PROJECT *(Name and Address)*
EAST HEIGHTS ELEMENTARY SCHOOL RENOVATION
1776 ADAMS LANE
HENDERSON, KY 42420

CHANGE ORDER NUMBER: 14-3
INITIATION DATE: 6/11/2025

PROJECT NUMBERS: 000847
CONTRACT DATE: 1/6/2025
CONTRACT FOR: BID PACKAGE #14 ELECTRICAL

Henderson County East Heights Elementary Renovation
PR #05 05/28/2025

Item #2 Refer to Sheet E2.23 – New Work Lighting Plan – Phase 2 – Area D

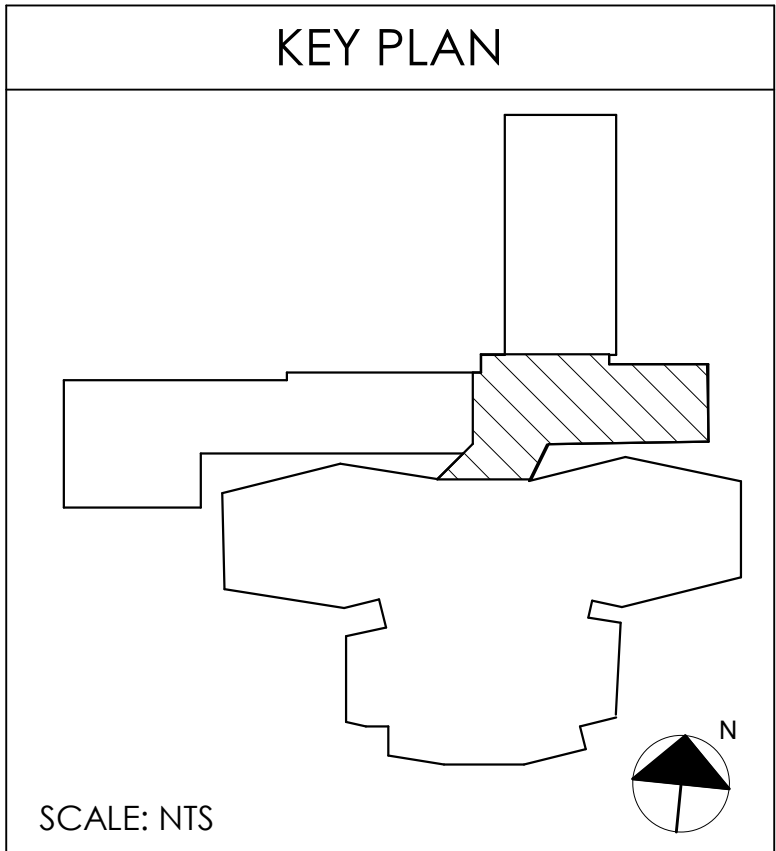
A. There were a total of six (6) Type B1 fixtures newly added to the Media Center space. Refer to home run pane-circuit number and update panel schedules as required.
